SP2024-032

PROJECT COMMENTS

PROJECT NAME: Site Plan for 855 Whitmore Drive

CASE CAPTION: Discuss and consider a request by Hooman Sedaghat of Buildeng, LLC on behalf of Salvador Salcedo for the approval of a Site Plan

ELEVATIONS

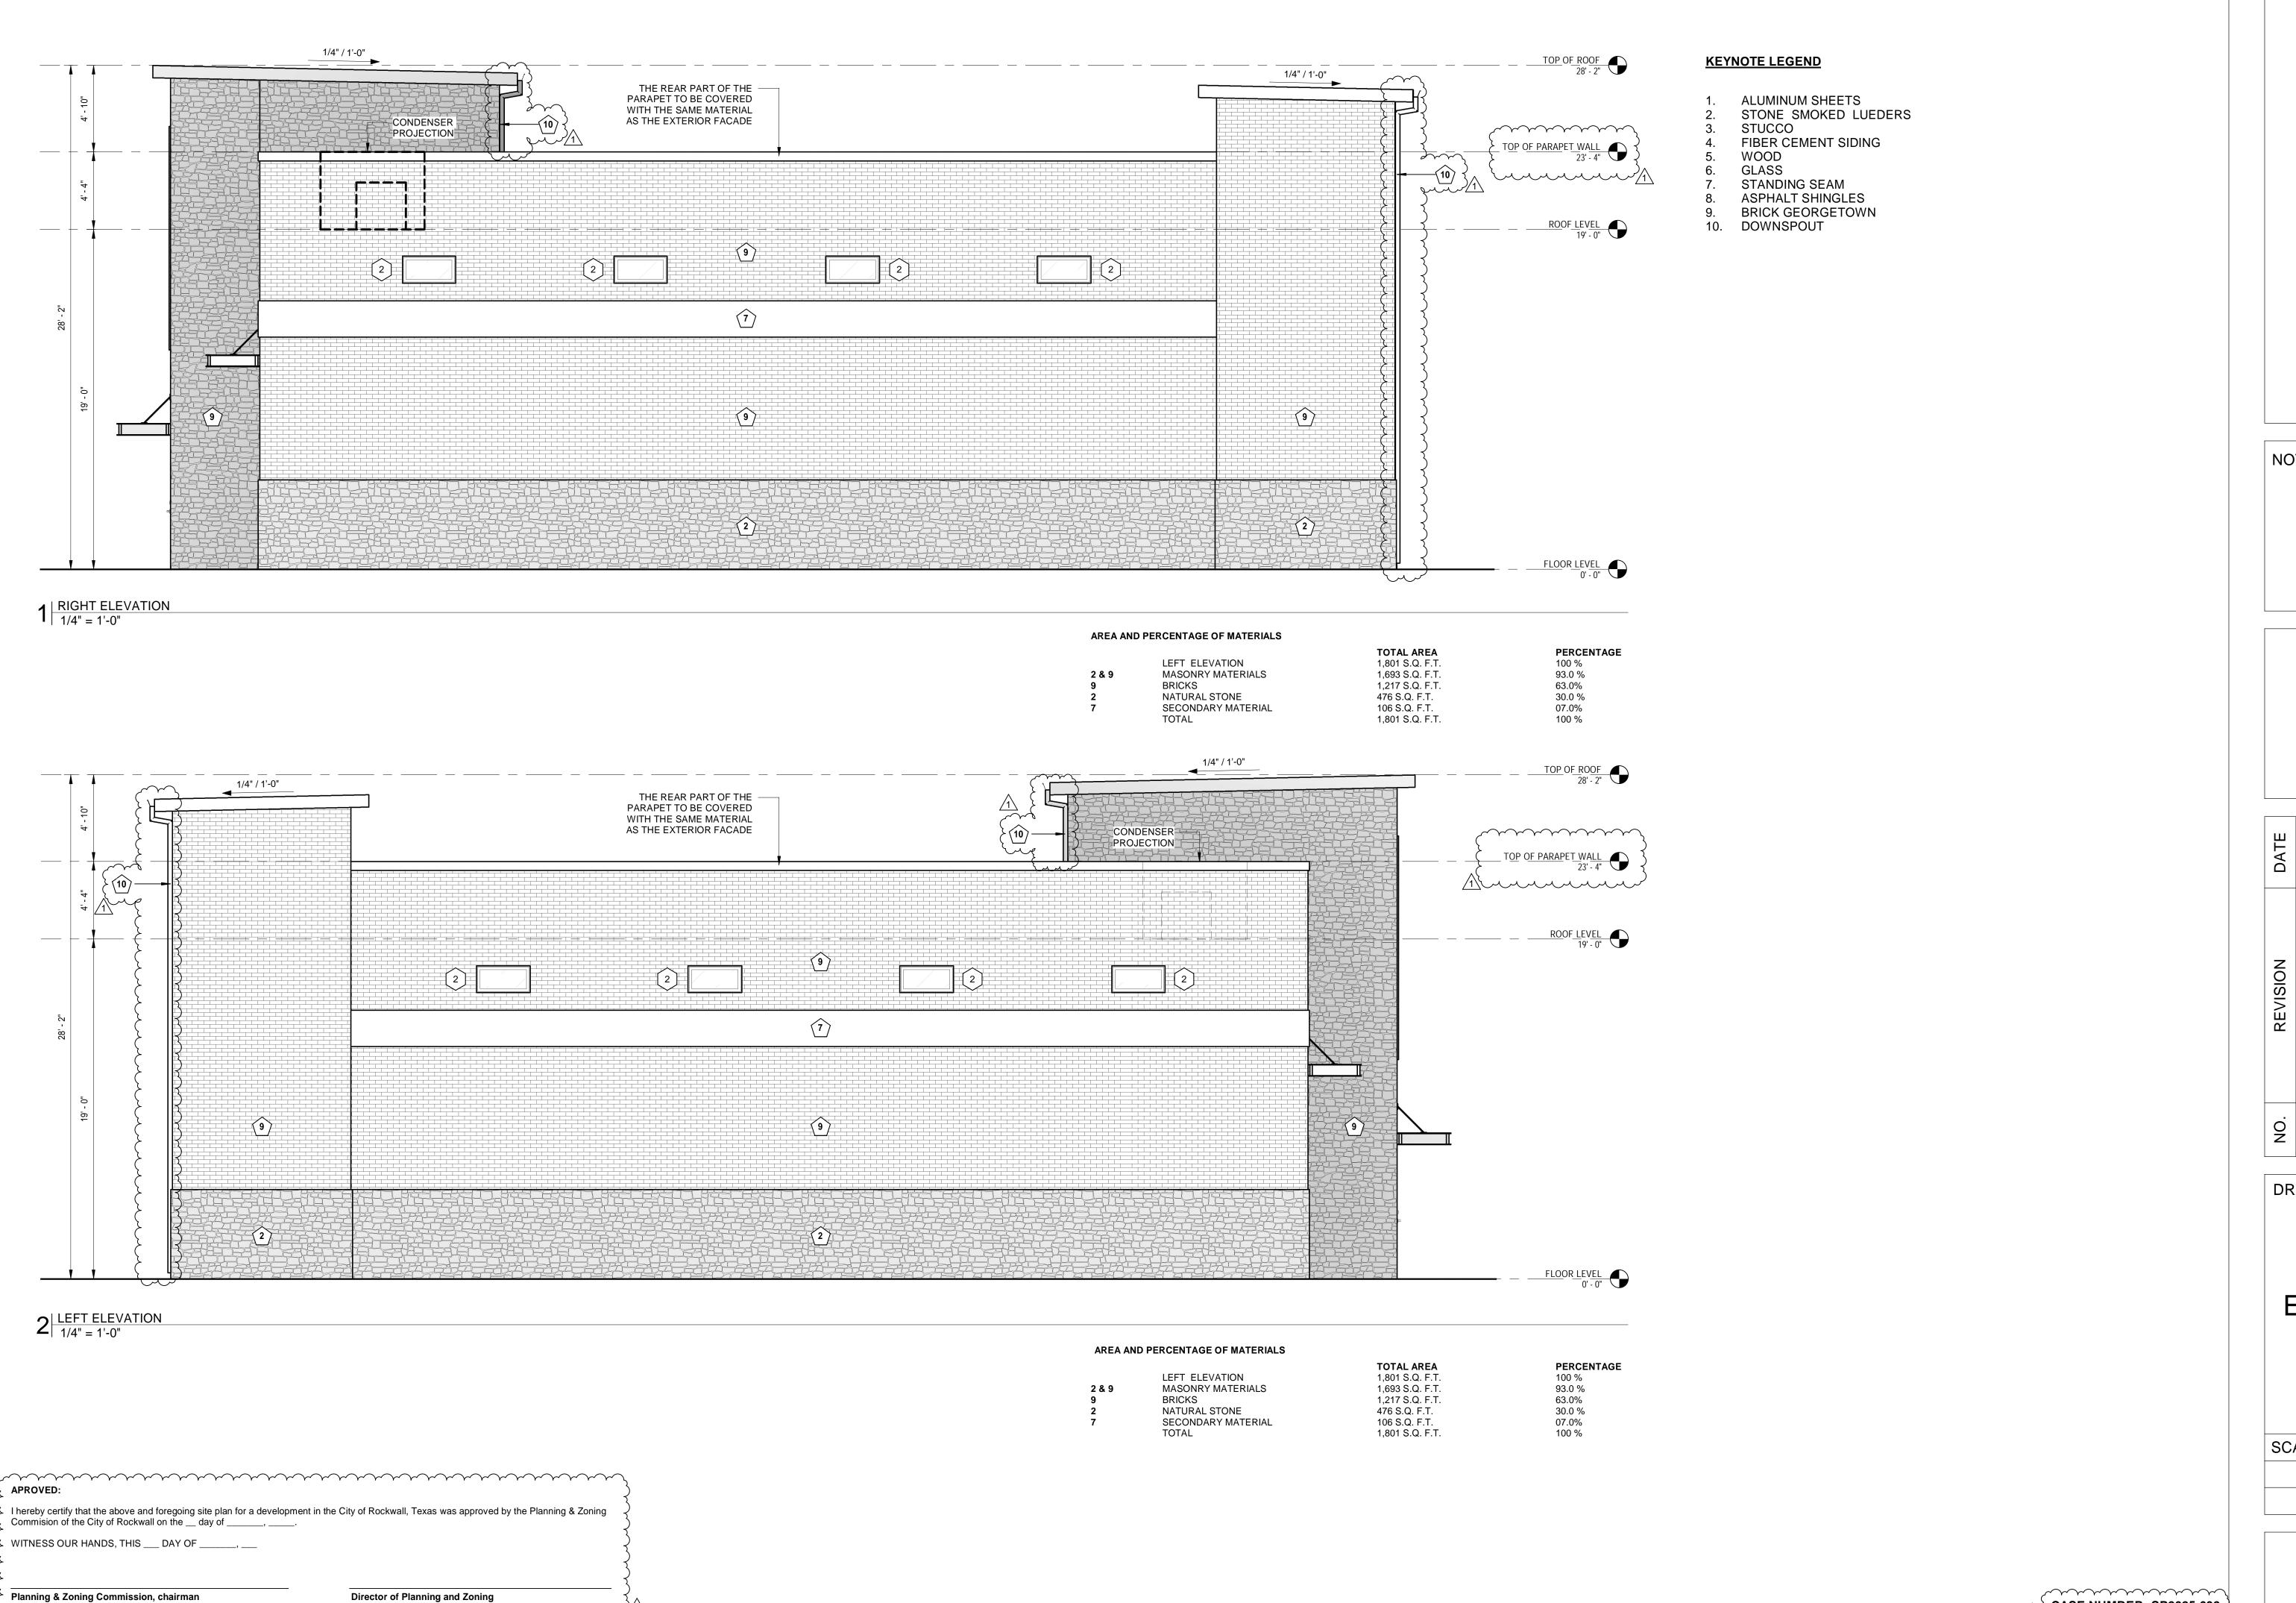
- (2) <u>Articulation</u>. According to Subsection 01.05, General Industrial District Standards, of Article 05, District Development Standards, of the Unified Development Code (UDC), all industrial buildings shall meet the primary and secondary articulation requirements outlined in Figure 13, Industrial Building Articulation Standards, of Article 05, District Development Standards, of the Unified Development Code (UDC). In this case, the primary façade facing onto Whitmore Drive, does <u>not</u> meet the primary articulation standards. This will require and <u>exception</u> from the Planning and Zoning Commission.

PHOTO -**METRICS DETAILS**

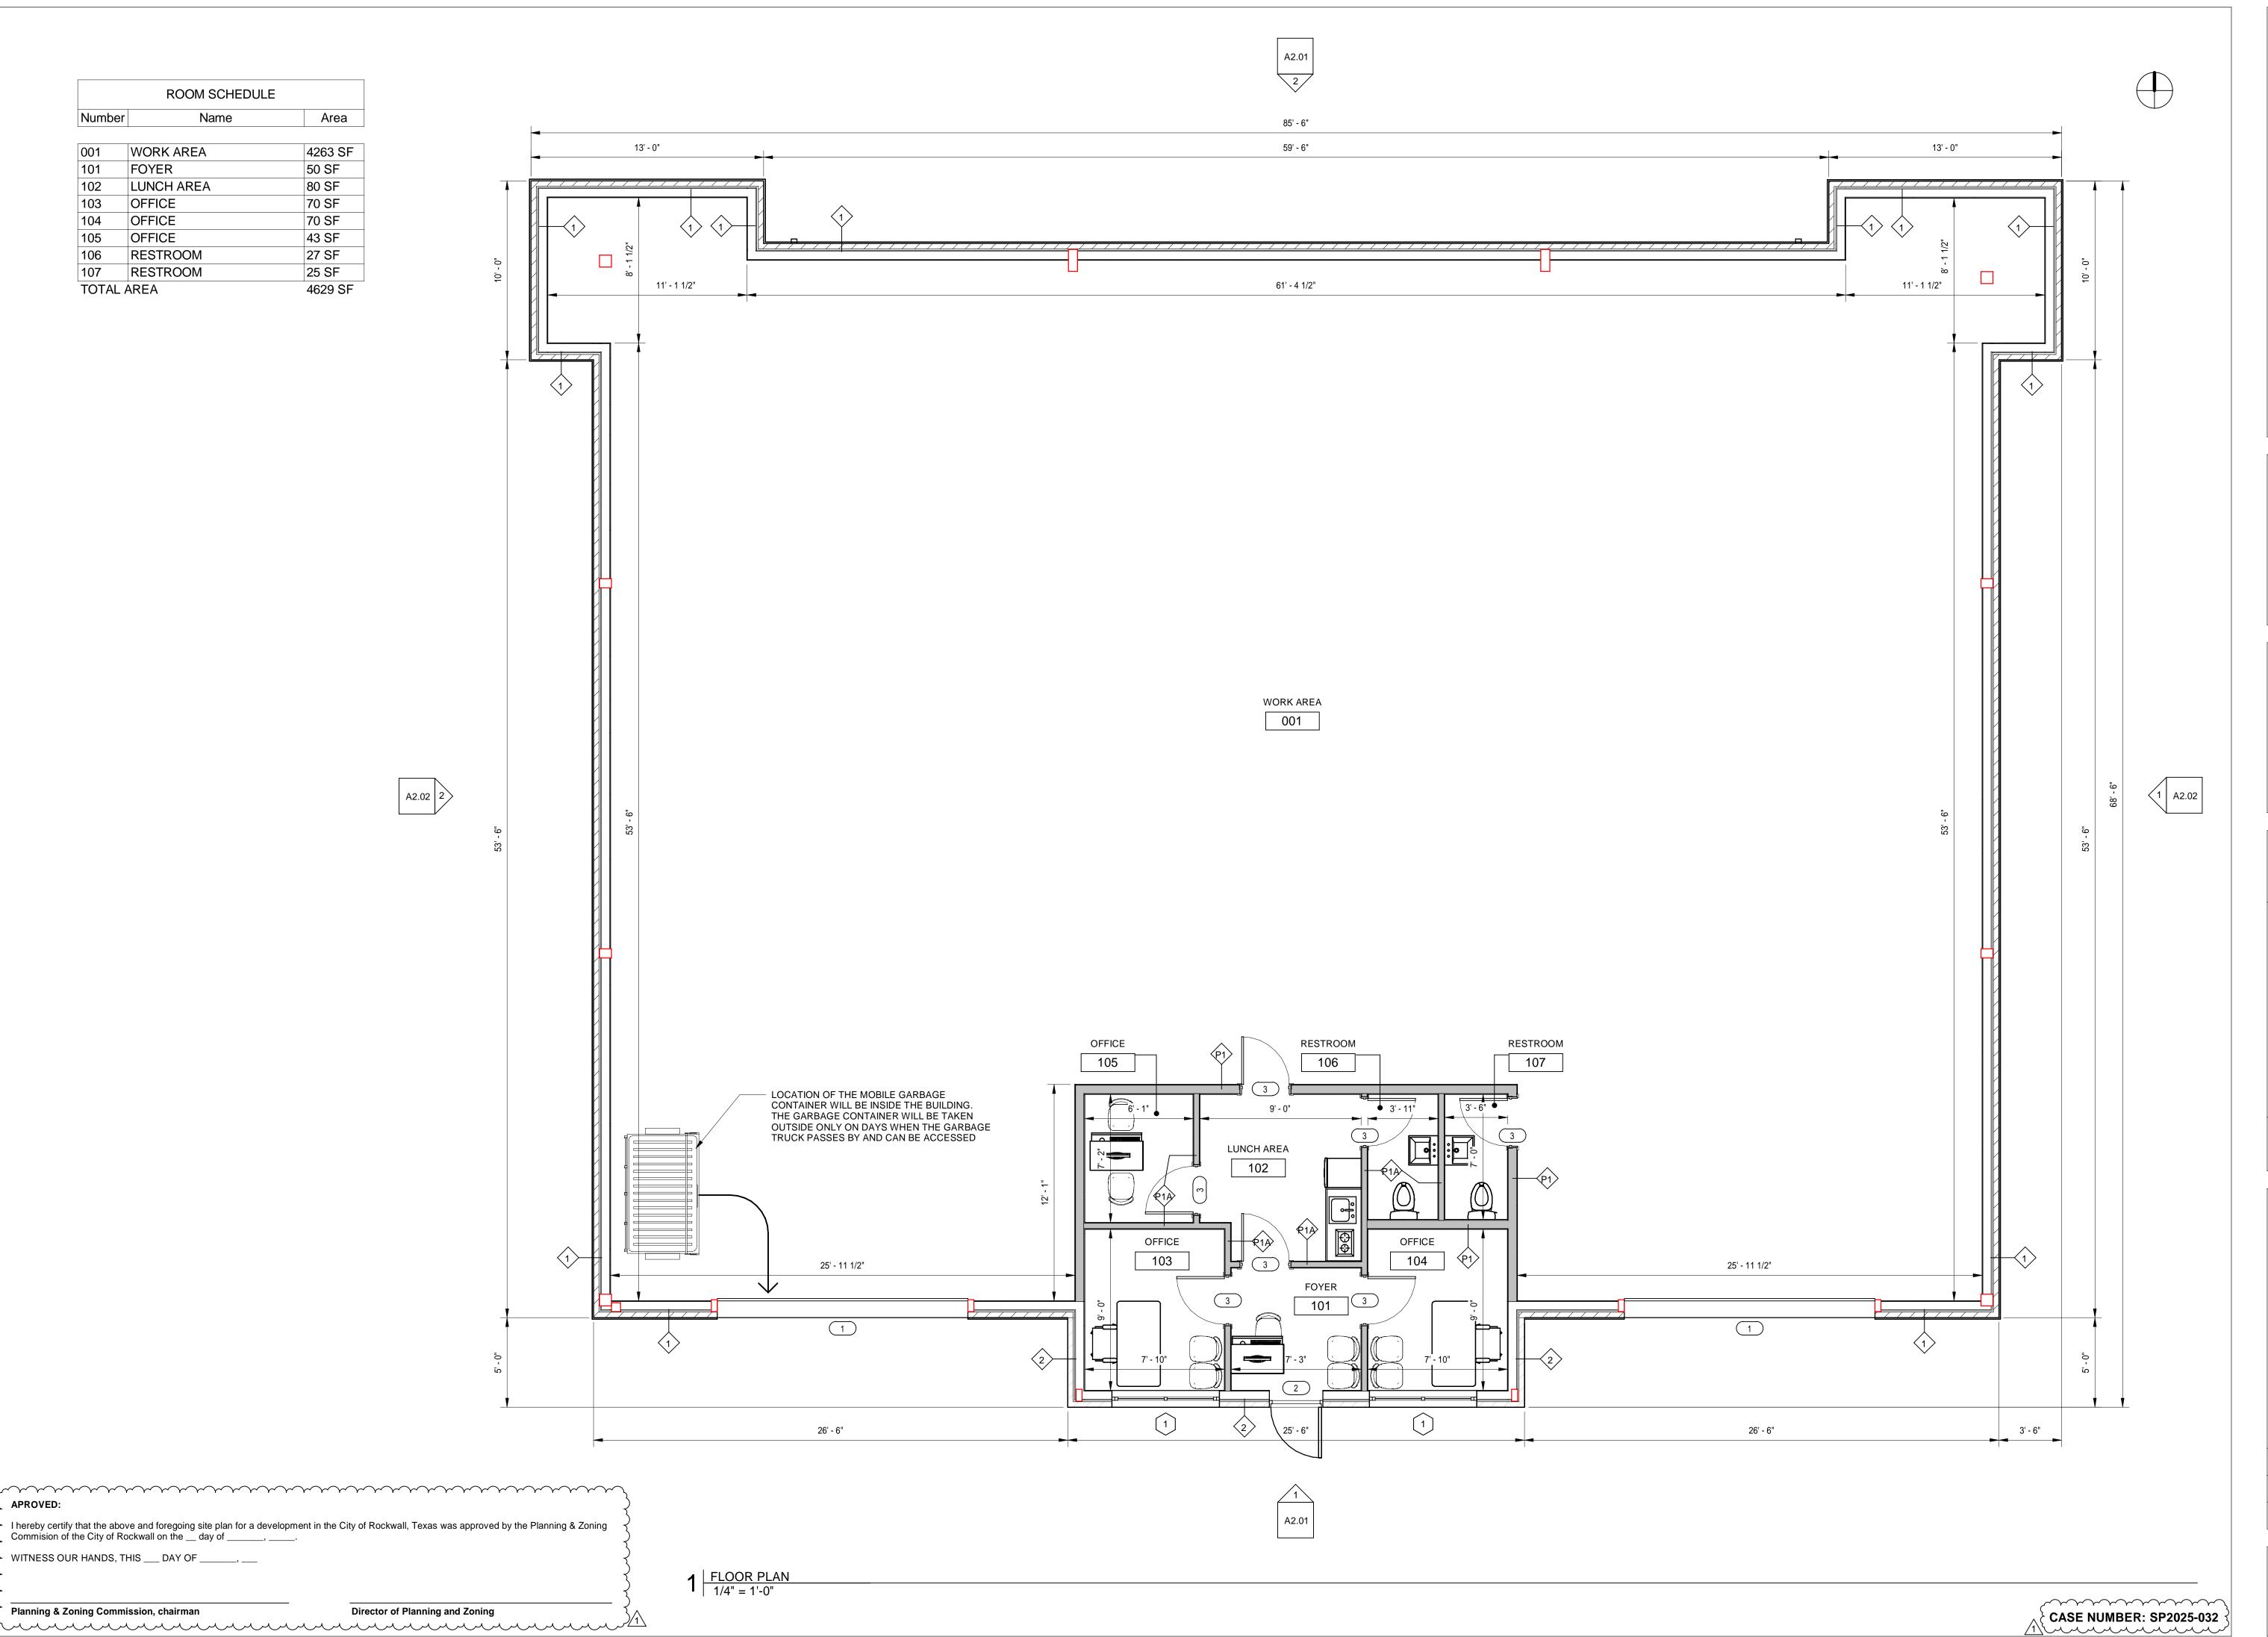
M.9 Photometric Plan

- (1) Provide the same site data information required in Section 2.1 Site Plan: Miscellaneous and Density and Dimensional Requirements of this checklist. (See Sec. 2.1 of the checklist)
- (2) Light levels shall not be greater than 0.2 FC at all property lines. Please provide the light levels at the property line. (Subsection 03.03, of Article 07, UDC)
- (3) All light fixtures shall be fully shielded and oriented downward. (Subsection 03.03, of Article 07, UDC)
